UNITED STATES PATENT AND TRADEMARK OFFICE

APPLICATION NO.	FILING DATE	FIRST NAMED INVENTOR	ATTORNEY DOCKET NO.	CONFIRMATION NO.
10/627,623	07/28/2003	Reuven Unger	P23593	4331

Office Action Summary	Application No. 10/627,623	Applicant(s) UNGER ET AL.	
	Examiner Ernesto Garcia	Art Unit 3679

DETAILED ACTION

Woodruff et al., 6,309,524

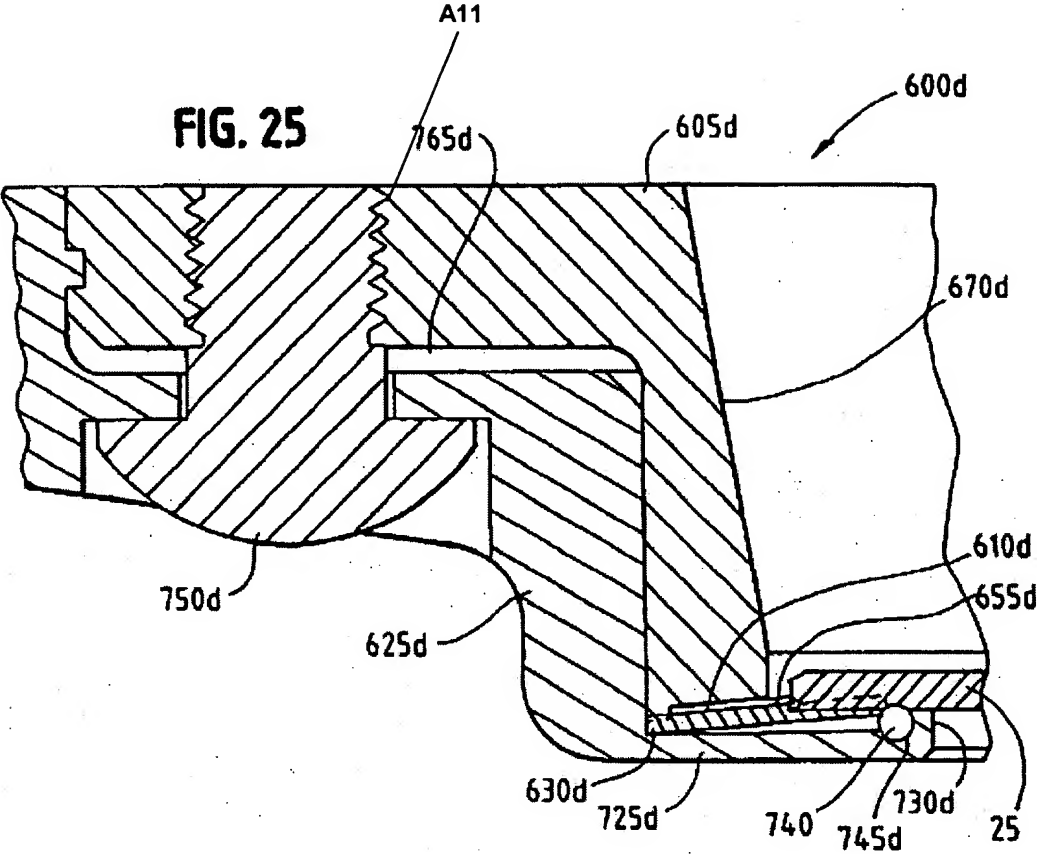
Claims 10 and 14 are rejected under 35 U.S.C. 102(b) as being anticipated by Woodruff et al., 6,309,524 (see marked-up attachment).

Regarding claim 10, Woodruff et al. disclose, in Figure 25, a securing device comprising a spring **610d**, a generally annular spring support **625d**, a generally annular coupling ring **605d**, and threaded holes **A11** in the coupling ring **605d**. The spring support **625d** includes a spring mount **725d** projecting in an inner side **765d** of the spring support **625d** and configured to support the spring **610d**.

Regarding claim 14, the threaded holes **A11** are at an interval of approximately 90 degrees or 180 degrees on the coupling ring **605d**.

Brunais et al., 4,333,434

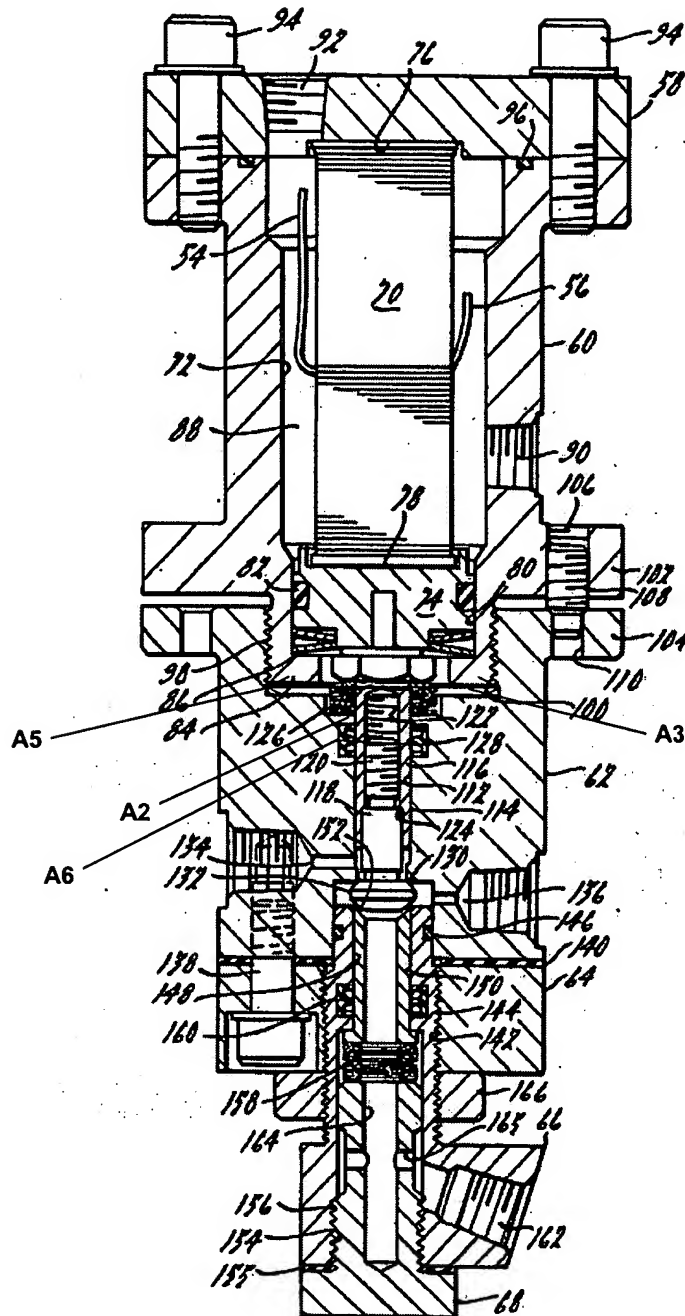
Claims 10-12 and 14 are rejected under 35 U.S.C. 102(b) as being anticipated by Brunais et al., 4,333,434 (see marked-up attachment).

Regarding claim 10, Brunais et al. disclose, in Figure 2, a securing device comprising a spring **126**, a generally annular spring support **62**, a generally annular coupling ring **60**, and threaded holes **106** in the coupling ring **60**. The spring support **62** includes a spring mount **A2** projecting in an inner side **A3** of the spring support **62** and configured to support the spring **126**.

Regarding claim 11, the spring support **62** has a first inner diameter **A5** and second inner diameter **A6**. The spring mount **A2** radially inwardly projects at a region between the first inner diameter **A5** and the second inner diameter **A6**.

Regarding claim 12, a first thread **100** is formed on an inner periphery of the spring mount **A2**. A second thread **98** is formed on an outer periphery of the coupling ring **60**.

Regarding claim 14, the threaded holes **106** are at an interval of approximately 90 degrees or 180 degrees on the coupling ring **60**.
